SUMTER COUNTY BOARD OF COMMISSIONERS
EXECUTIVE SUMMARY

SUBJECT: Change Order # 1 for Greg Construction
REQUESTED ACTION: **Request BOCC to sign Owner Change Order**

PROJECT: (name, address) Sumter County - Security Entry Vestibule
225 East McCollum Av enue
Bushnell, FL 3513

SUMTER COUNTY SECURITY VESTIBULE ENTRANCE-CHANGE ORDER #1 3/12/2010

Sumter County Security Vest

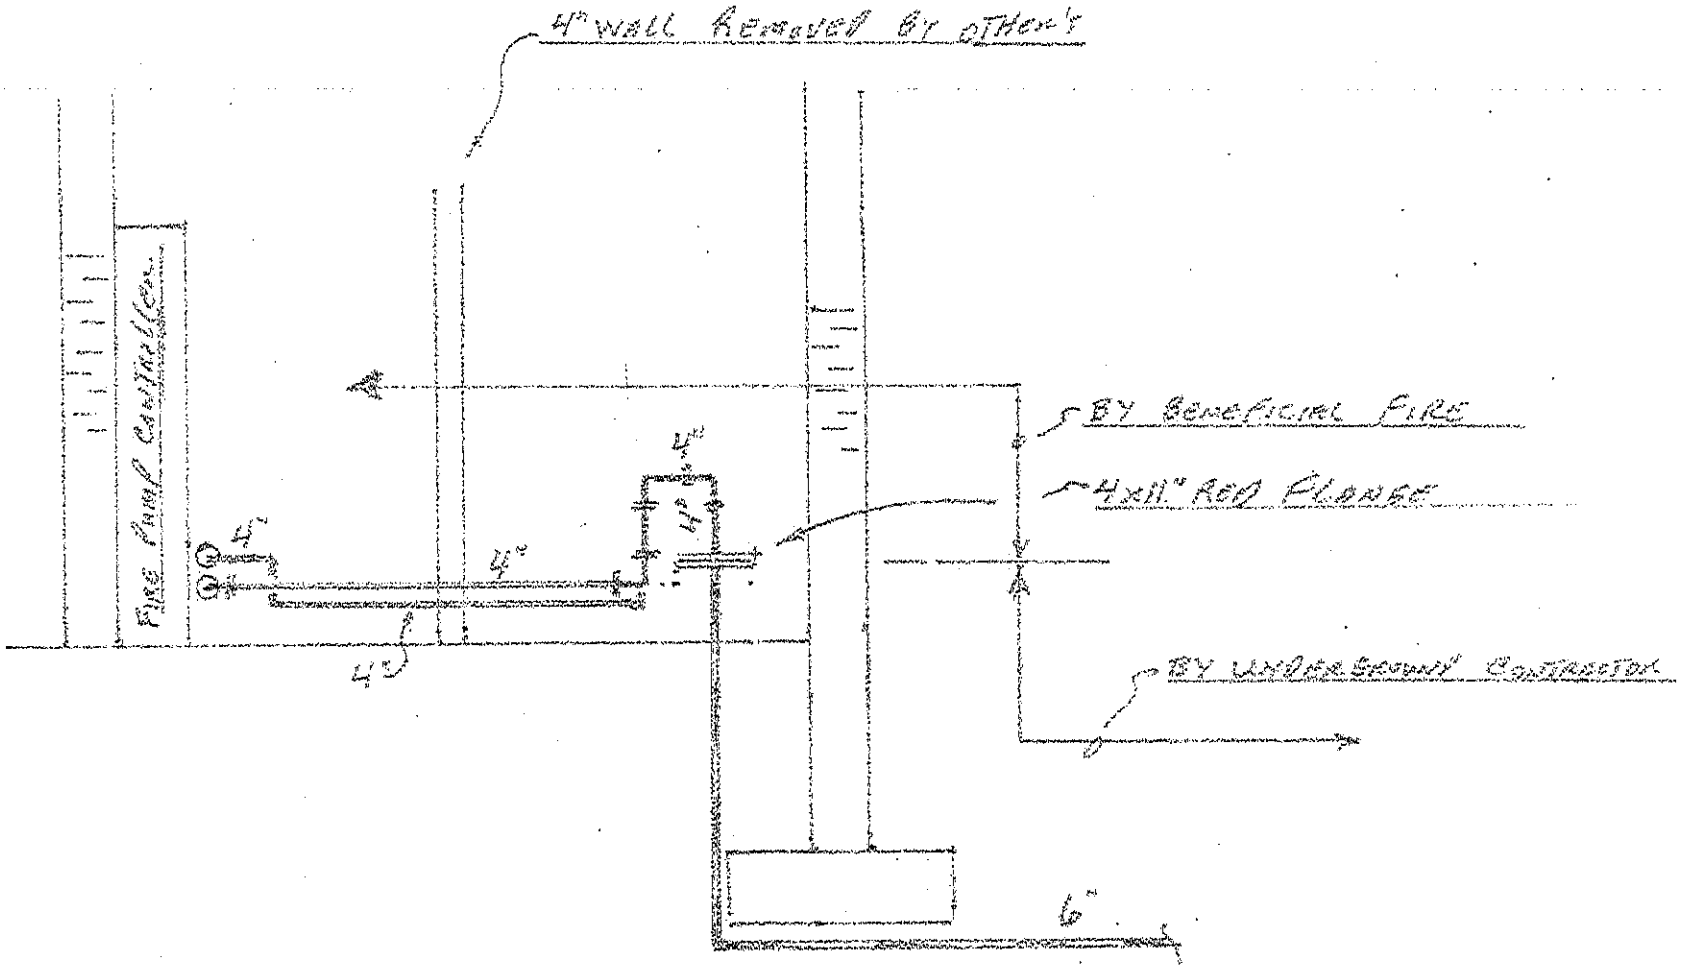
Per my meeting with Jeff Pfent on November 05, 2009 at the job site we are providing you with a price to connect the two 6" underground stub-in into the existing 4" FDC line and the 4" Fire pump feed in the existing pump room. There per our meeting we will tie onto new 6" flanged spigot pieces and reduce to 4" and run along floor to existing 4" connections per my sketch.

REVISION: 1 - ADD ELEVATOR SUMP PUMP	PROJECT: S.C.C.S.E.	
SUPPLEMENT TO DRAWING No.: P101	TLC JOB No.: 509012	SCALE: 1/4" = 1'-0"
DATE: 12/15/2009 DESIGN: MP CHECKED: JCM	874 Dixon Blvd. Cocoa, Florida 32922 Phone: 321-636-0274 Fax: 321-639-8986 www.tlc-engineers.com	SKETCH No. SKP101-1

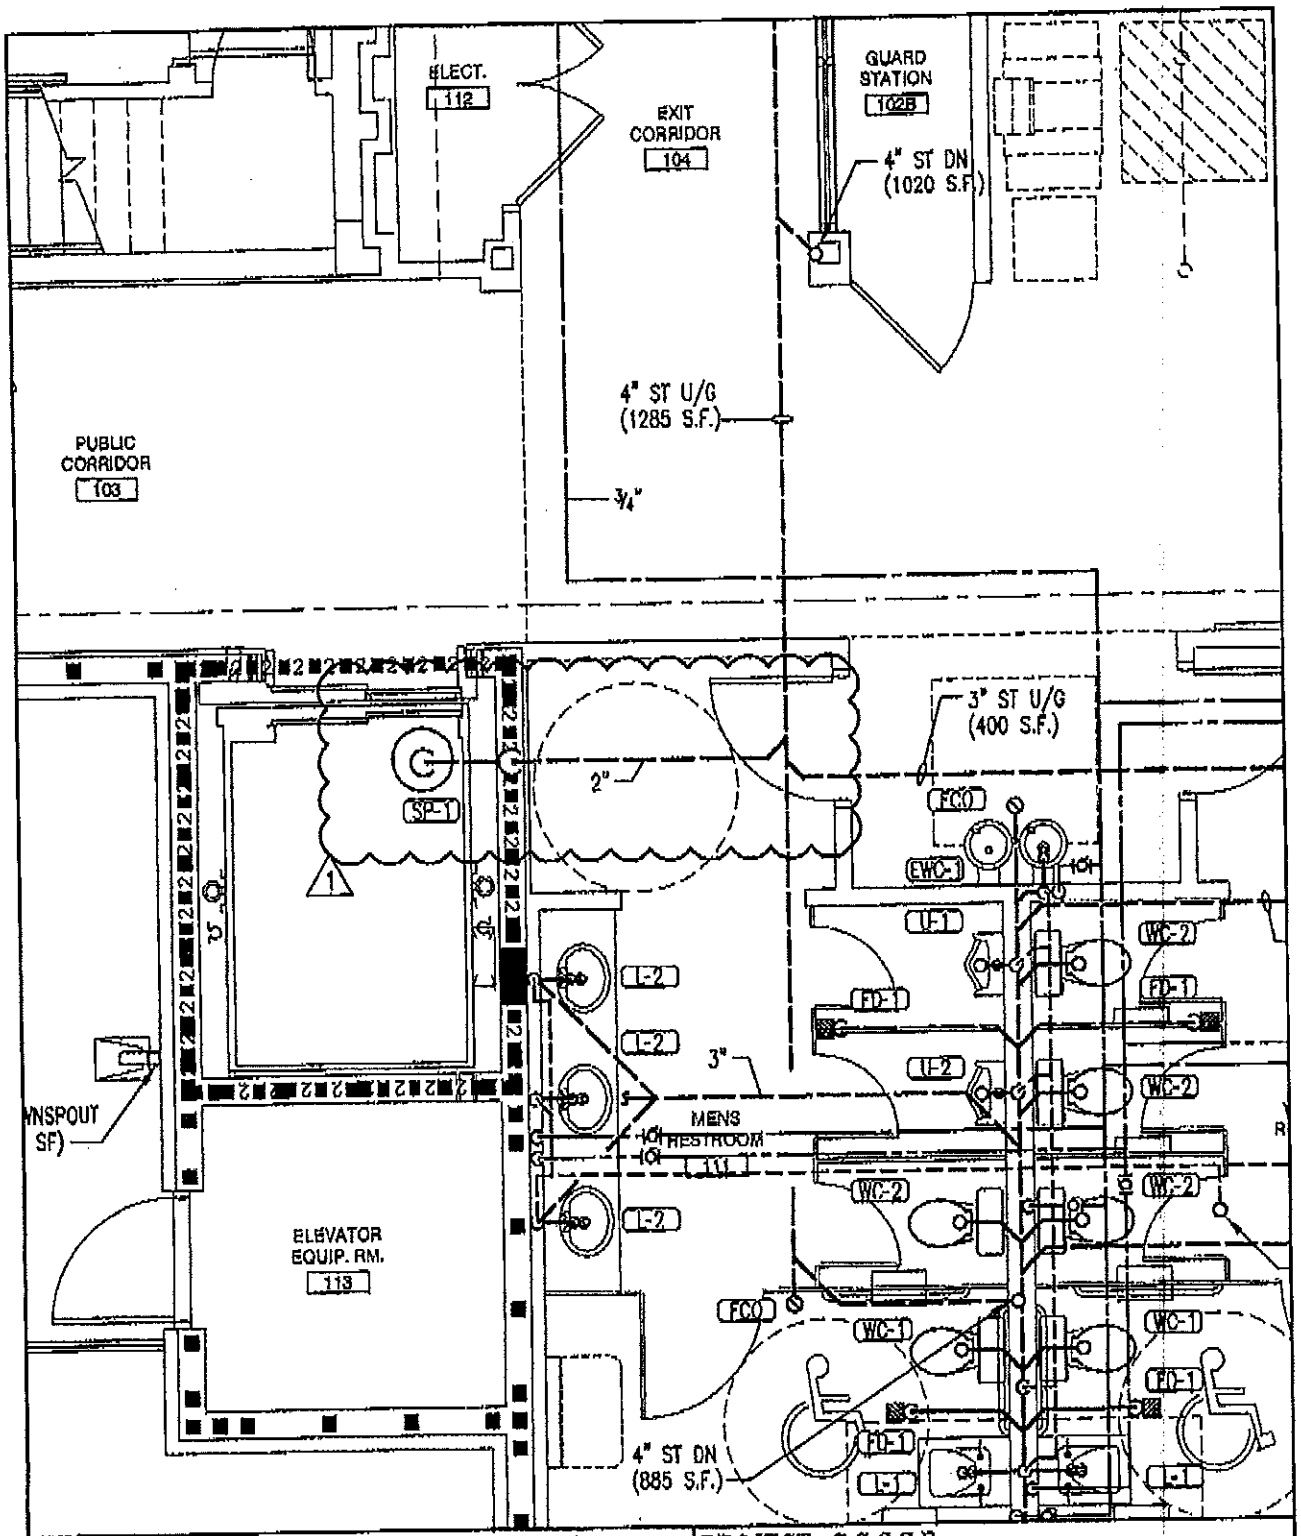
DATE: January 13, 2010
SUBMITTED TO: Greg Construction
REFERENCED PROJECT: Sumter County Security Vestibule Entrance
CHANGE ORDER BY: Sketch SKP100-1
EXTRA WORK REQUESTED: Add sump pump in elevator and piping.
